## **Technical Service Information**

## THM 4L60 (700-R4) NO WOT 3-4 UPSHIFT (POLICE ONLY)

Figure 1

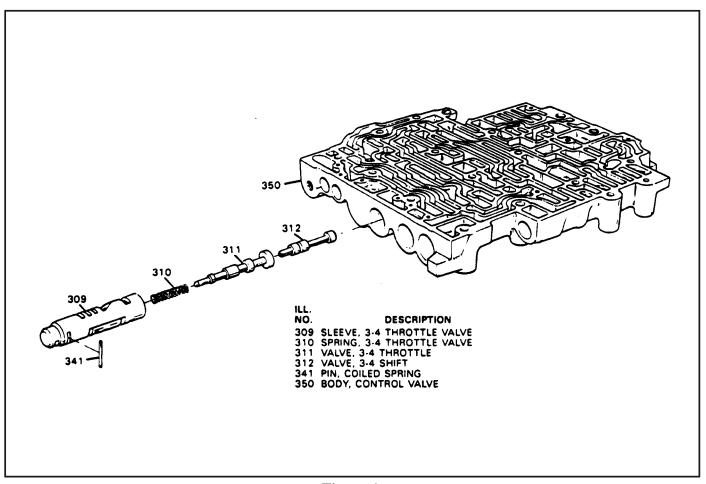
**COMPLAINT:** 5.7L "B" Car (Police Only) may exhibit a loss of wide open throttle upshift after vehicle is

hot.

**CAUSE:** The cause may be the wrong calibration.

**CORRECTION:** There is now available from OEM a new 3-4 throttle valve and sleeve assembly, in service

package part number 8671953, to address this condition. Refer to Figure 1 for proper

assembly procedure.
